Name: Fayette County Health Department
Building Renovations

A2H #: 23406

Addendum #: 1

Date of Issuance: 7/12/24

D3 FLOOR PLAN - DEMOLITION
3/16" = 1'-0"

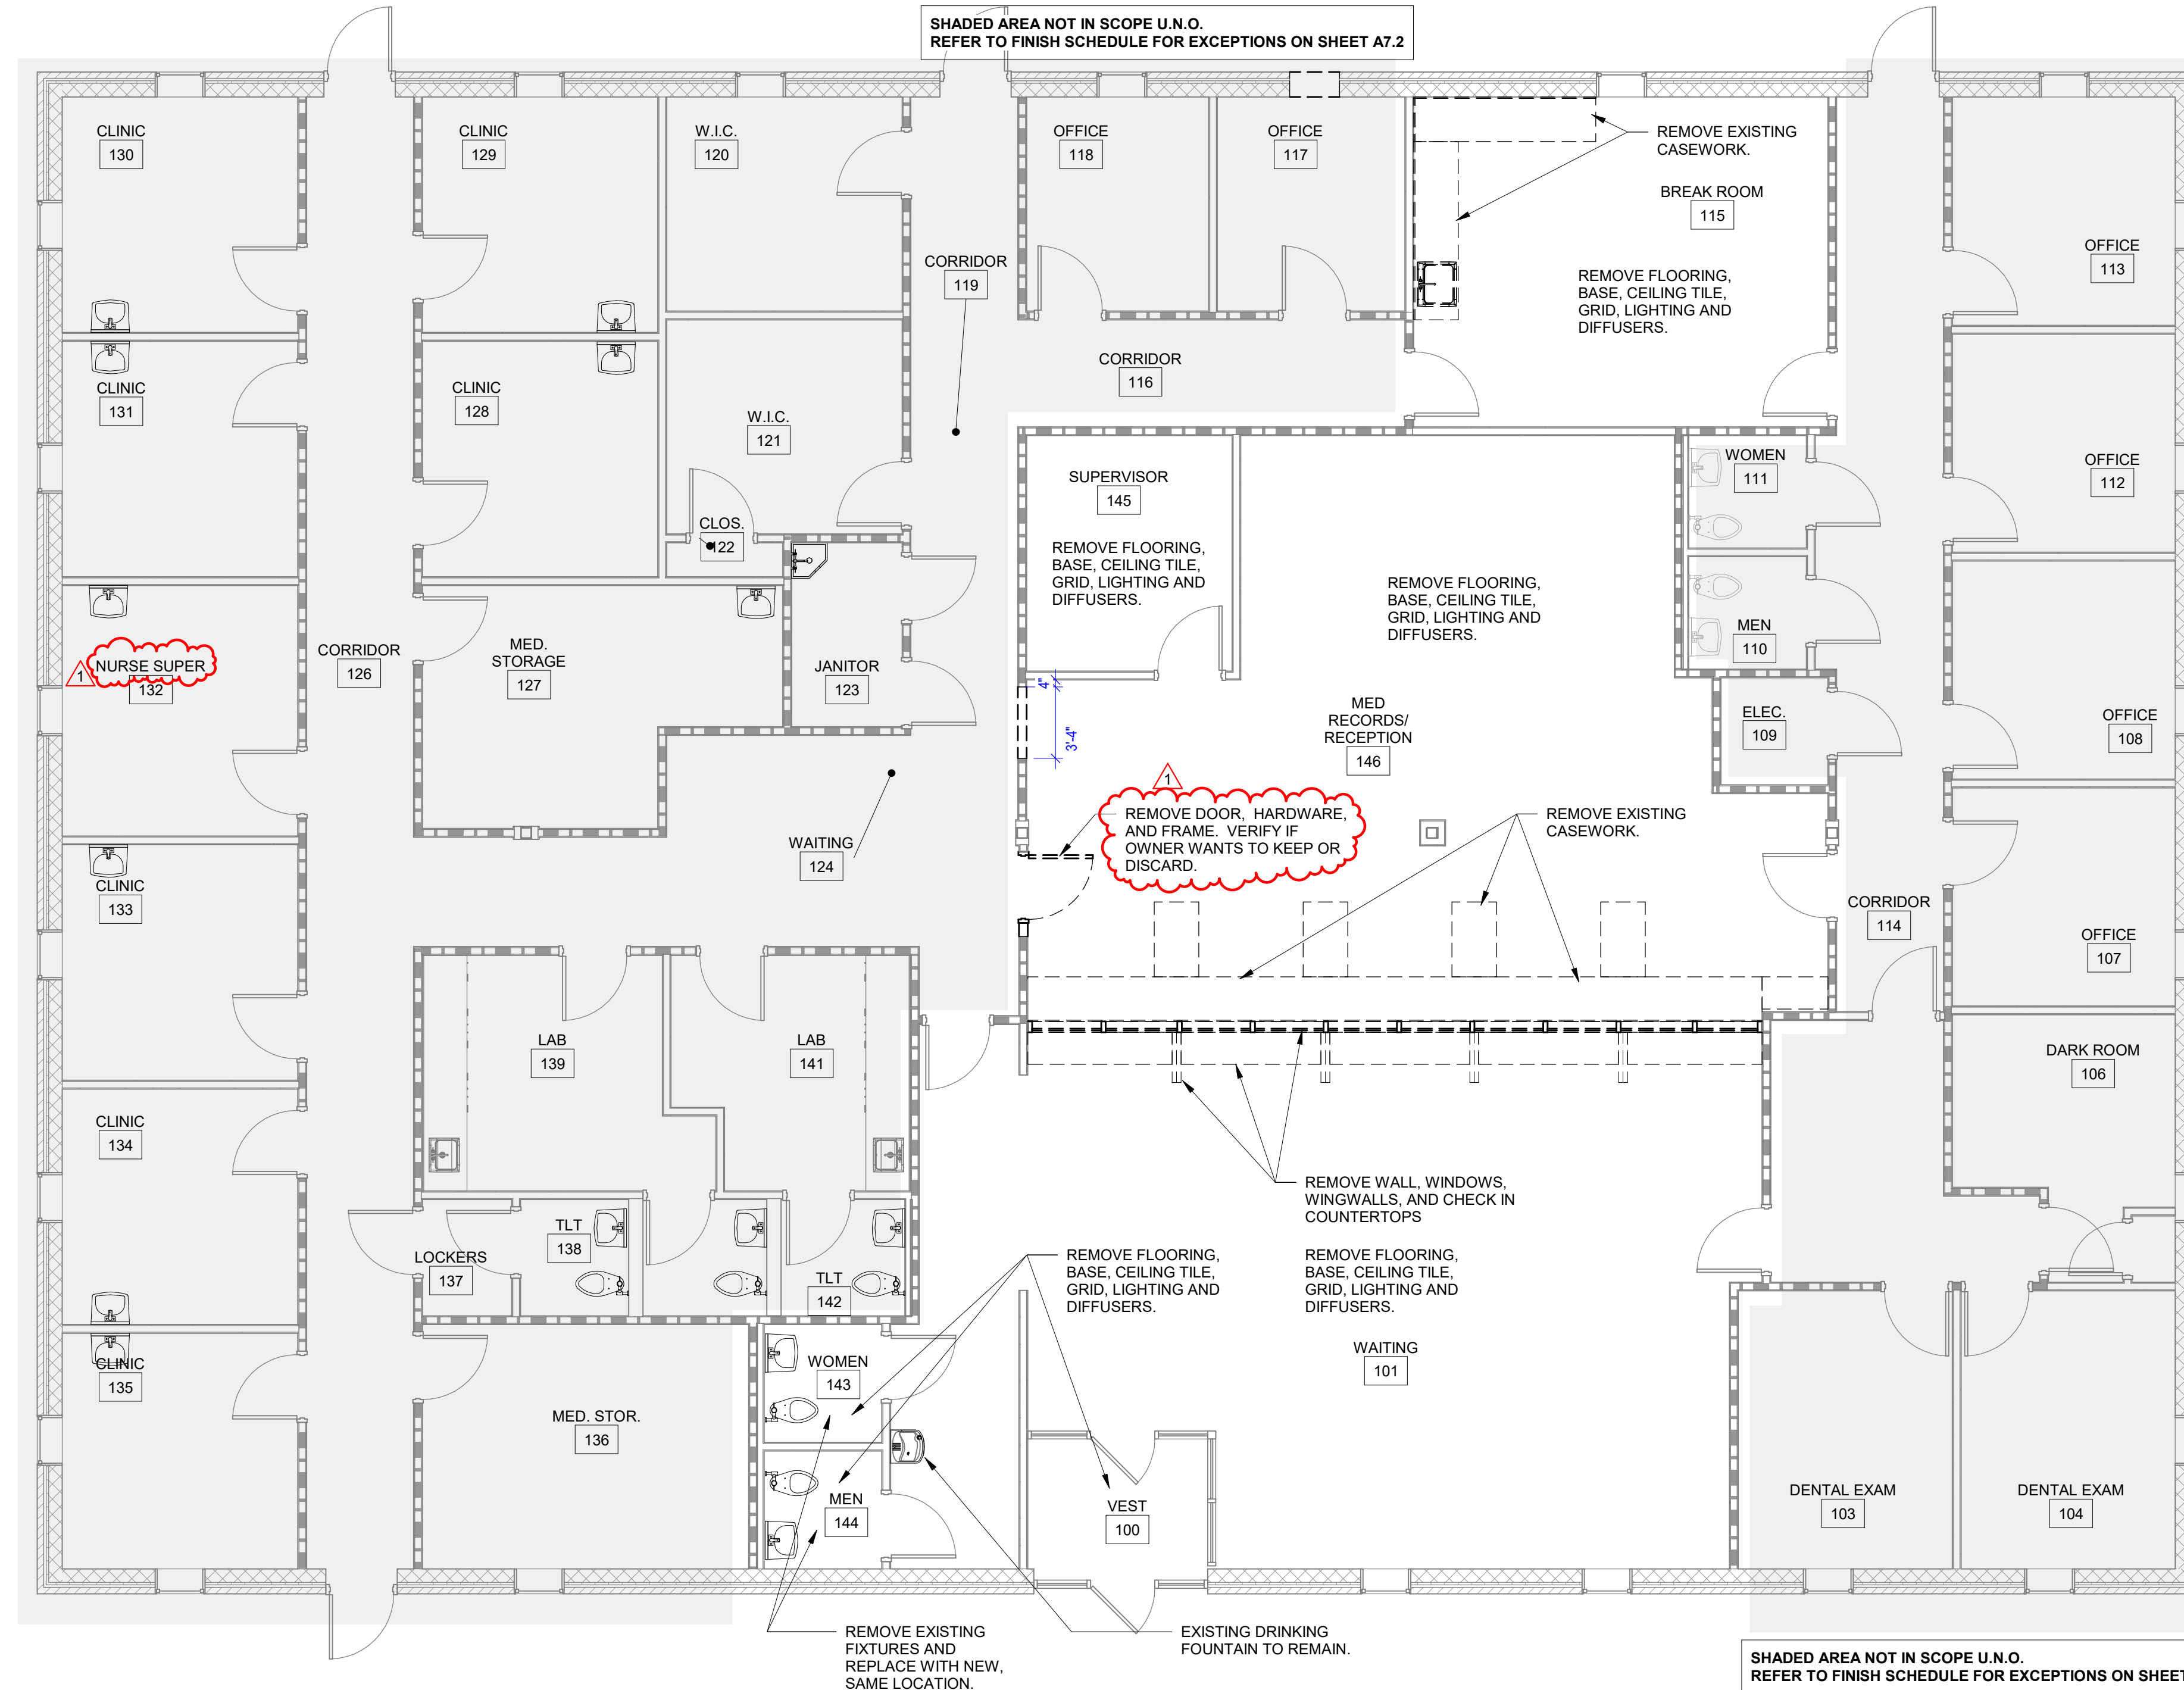
1. A0.1 - FLOOR PLAN - EXISTING / DEMOLITION
 - a. Clouded Note at demolished door in Med. Records/ Reception 146 changed: REMOVE DOOR, HARDWARE, AND FRAME. VERIFY IF OWNER WANTS TO KEEP OR DISCARD.

- b. Clouded name to room number 132 changed to NURSE SUPER.
2. A1.0 - FLOOR PLAN – NOTED
 - a. Clouded name to room number 132 changed to NURSE SUPER.
 - b. Clouded Note at new door in Med. Records/ Reception 146 changed to read: NEW SOLID CORE WOOD FLUSH / DUTCH DOOR AND METAL FRAME TO MATCH EXISTING MATERIAL AND FINISH. DOOR HARDWARE TO BE OFFICE FUNCTION.

D2 FLOOR PLAN - NOTED
3/16" = 1'-0"

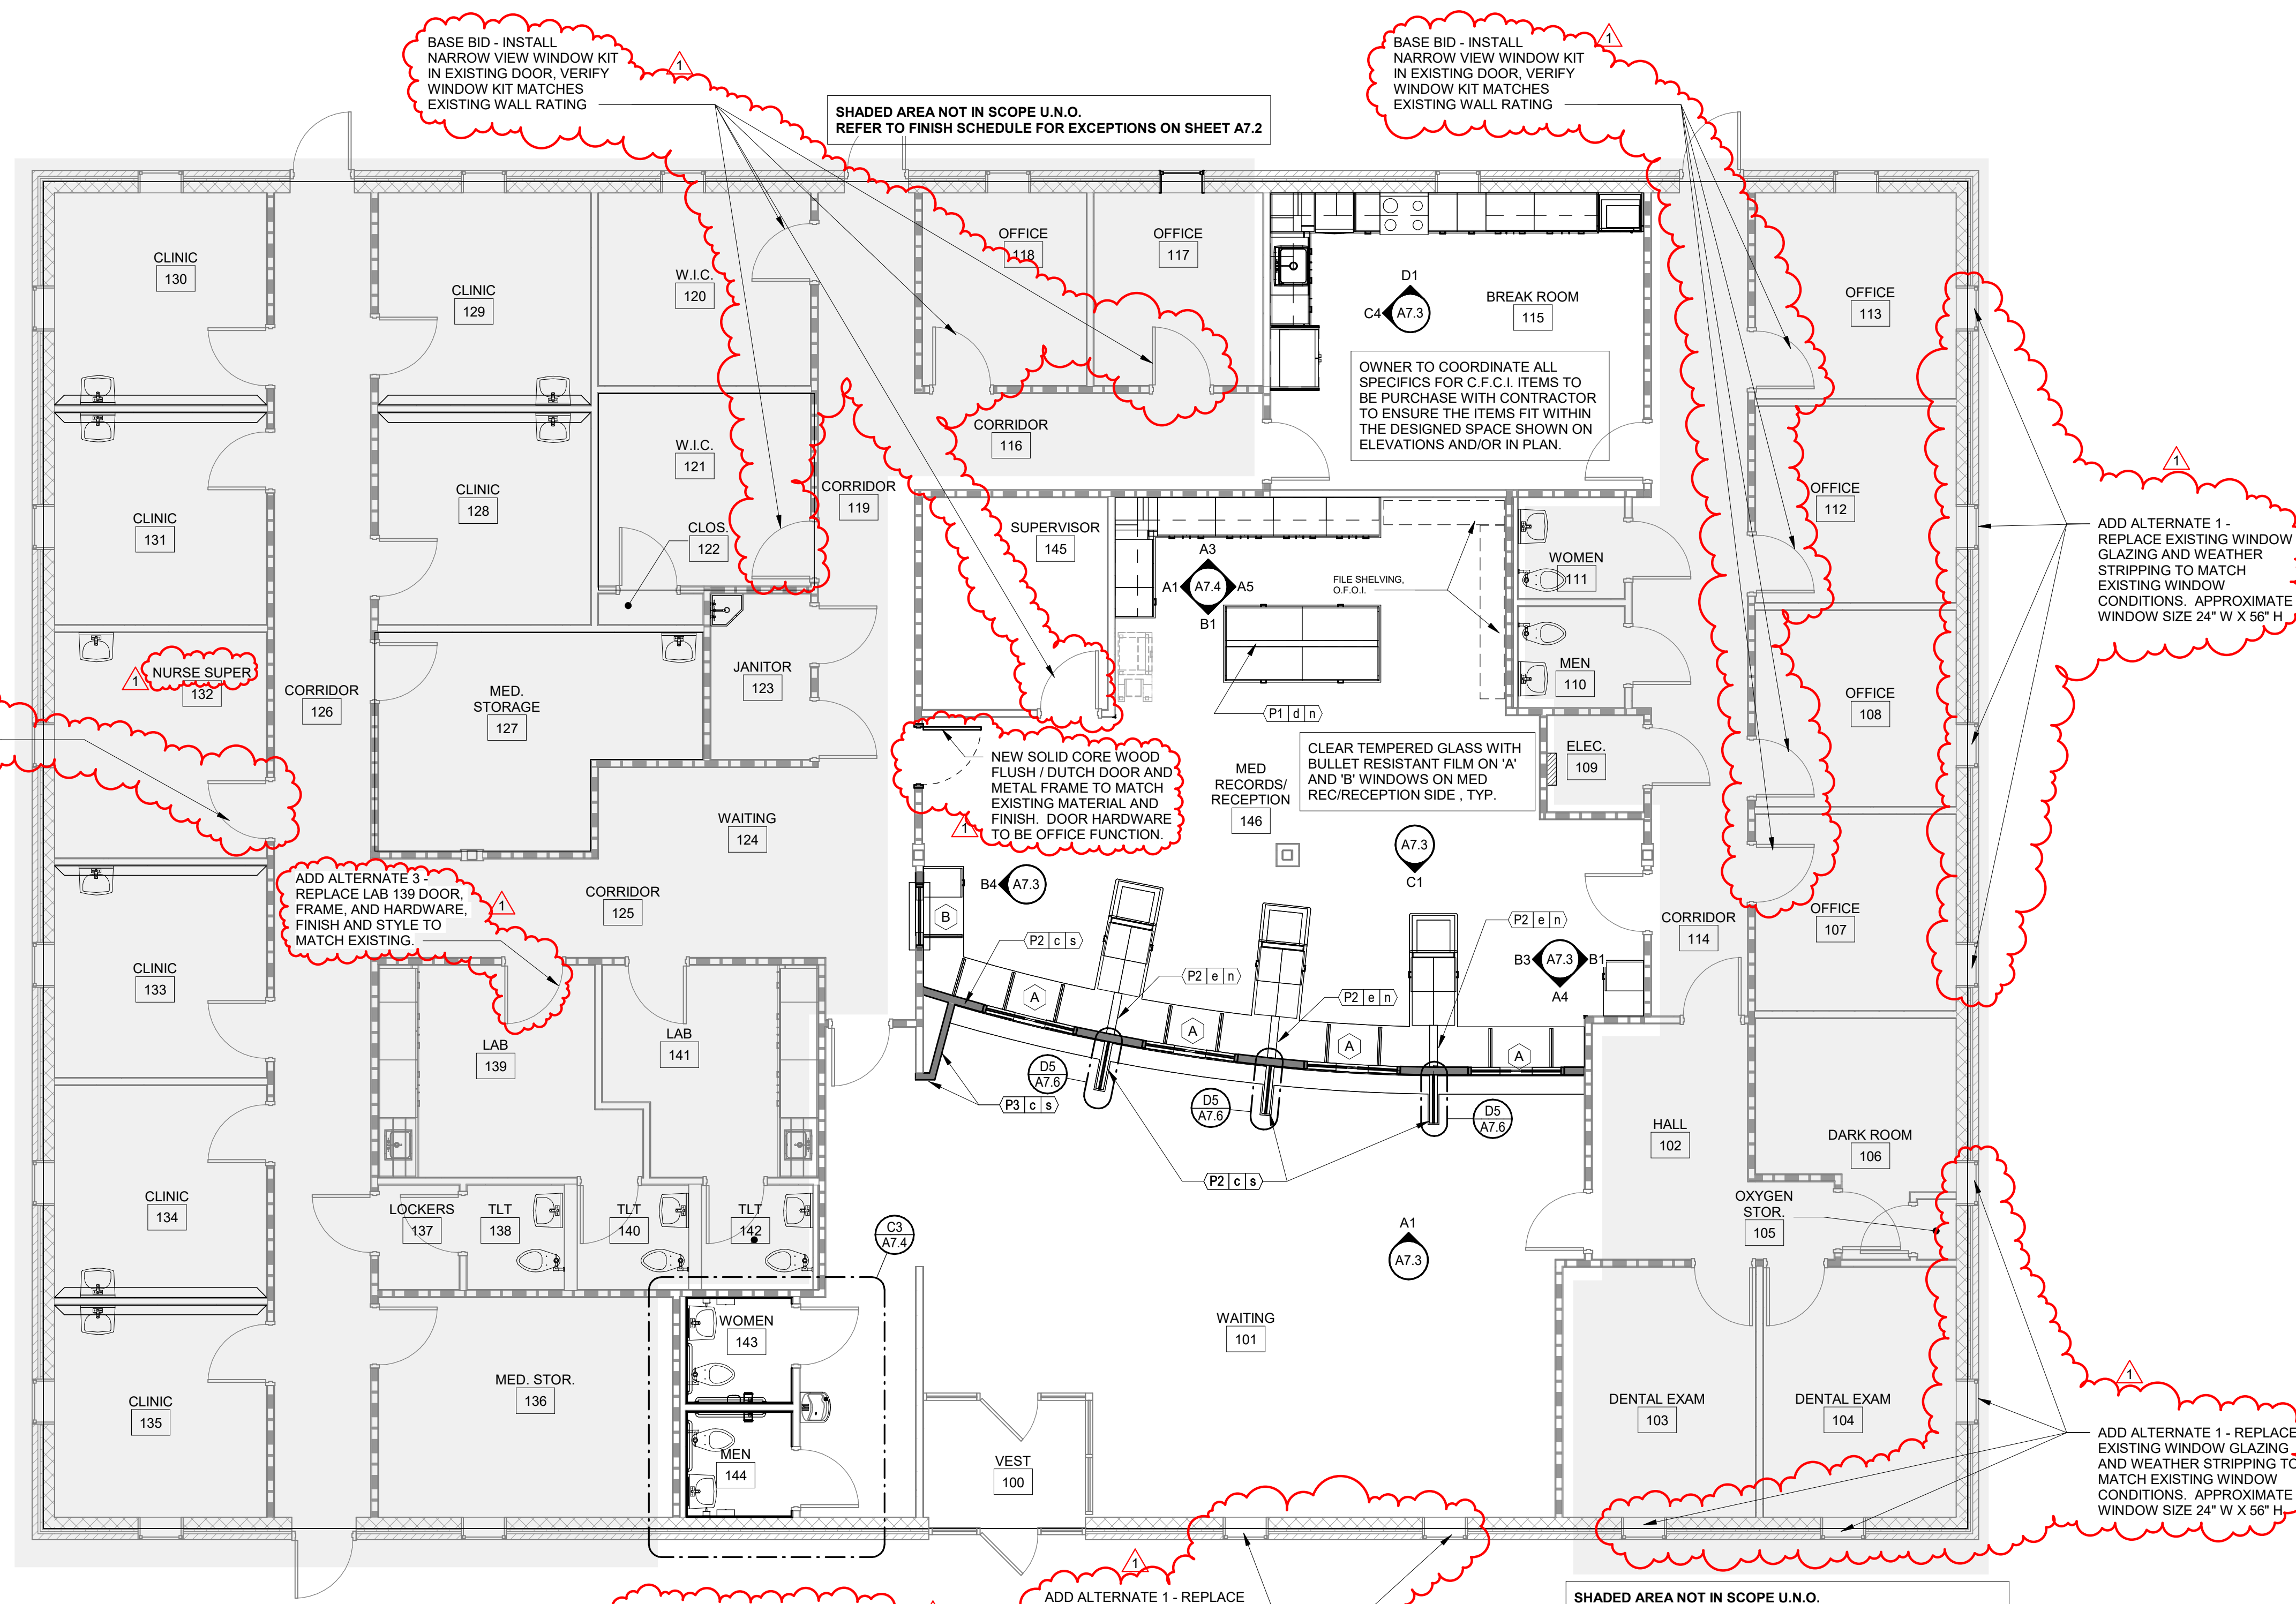
- c. Add clouded note for doors in NURSE SUPER 132, W.I.C. 121, W.I.C. 120, OFFICE 118, OFFICE 117, SUPERVISOR 145, OFFICE 113, OFFICE 112, OFFICE 108, and OFFICE 107 reading, BASE BID - INSTALL NARROW VIEW WINDOW KIT IN EXISTING DOOR, VERIFY WINDOW KIT MATCHES EXISTING WALL RATING.

- d. Add clouded note for designated windows, **ADD ALTERNATE 1** - REPLACE EXISTING WINDOW GLAZING AND WEATHER STRIPPING TO MATCH EXISTING WINDOW CONDITIONS. APPROXIMATE WINDOW SIZE 24" W X 56" H

- e. Add clouded note for door at LAB 139, **ADD ALTERNATE 3** - REPLACE LAB 139 DOOR FRAME AND HARDWARE, FINISH AND STYLE TO MATCH EXISTING.
 - f. Add clouded note, WHERE "BULLET RESISTANT FILM" IS REFERENCED, USE 3M™ SCOTCHSHIELD™ SAFETY & SECURITY WINDOW FILM ULTRA PRESTIGE SERIES AS BASIS OF DESIGN, TYP.

C4 SHEET VINYL ZERO TRANSITION
12" = 1'-0"

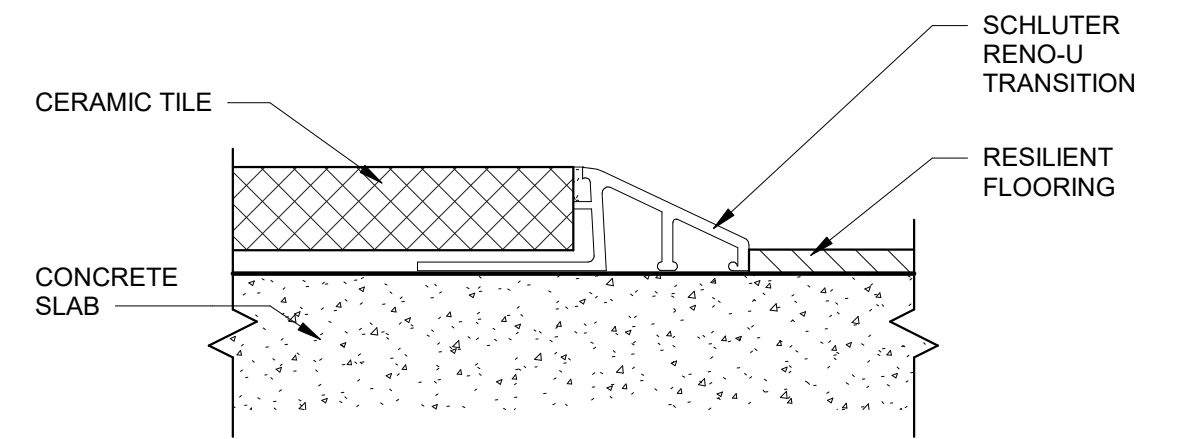
4. A7.1 – FINISH DETAILS
 - a. Add Clouded details C4 SHEET VINYL ZERO TRANSITION, and D4 SHEET VINYL COVE BASE DETAIL.
5. A7.2 - FINISH PLAN AND SCHEDULES

C1 ENLARGED RESTROOM FINISH PLAN
1/4" = 1'-0"

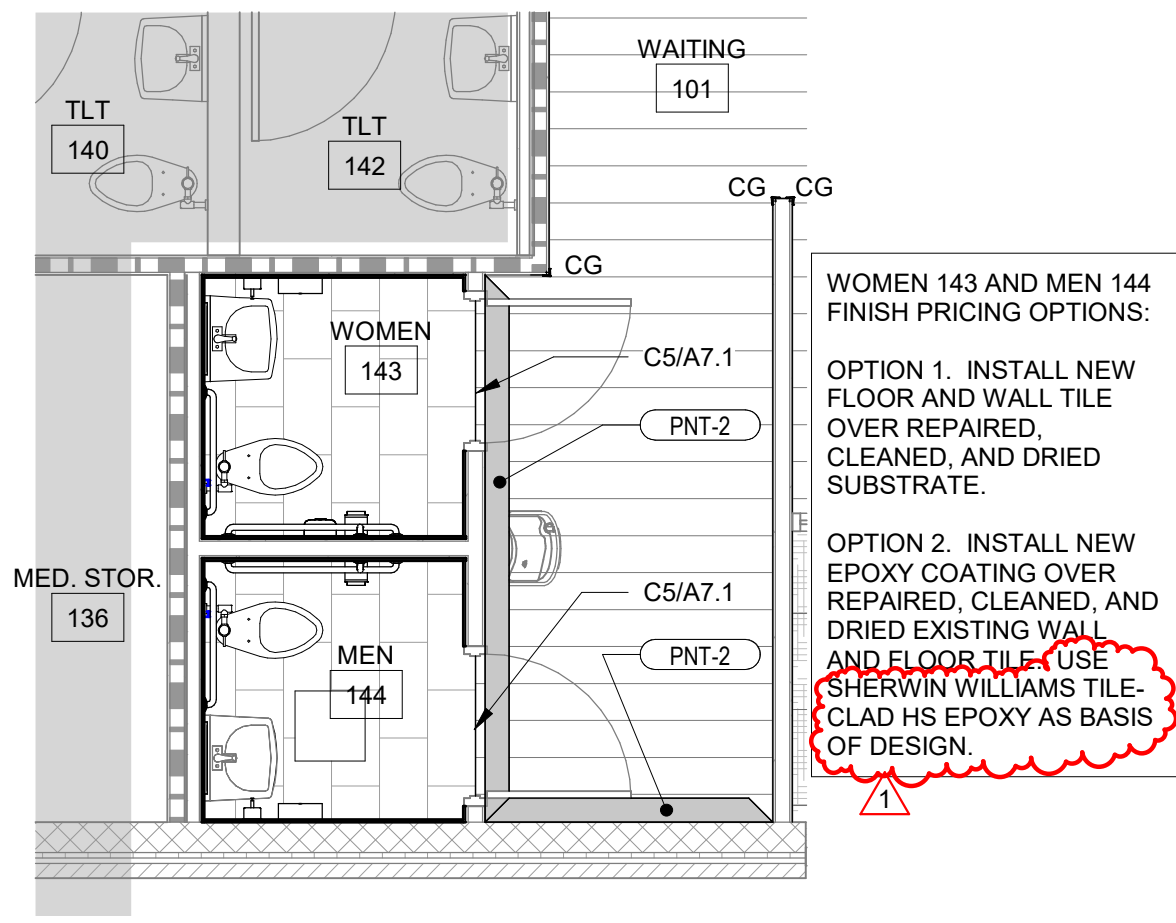
- i. Add clouded changes to FINISH SCHEDULE designating **ADD ALTERNATE 2** and **ADD ALTERNATE 4** changes.
 - j. Add clouded note to Option 2 on C1 ENLARGED RESTROOM FINISH PLAN, USE SHERWIN WILLIAMS TILE-CLAD HS EPOXY AS BASIS OF DESIGN. **THIS WILL BE ADD ALTERNATE 5.**
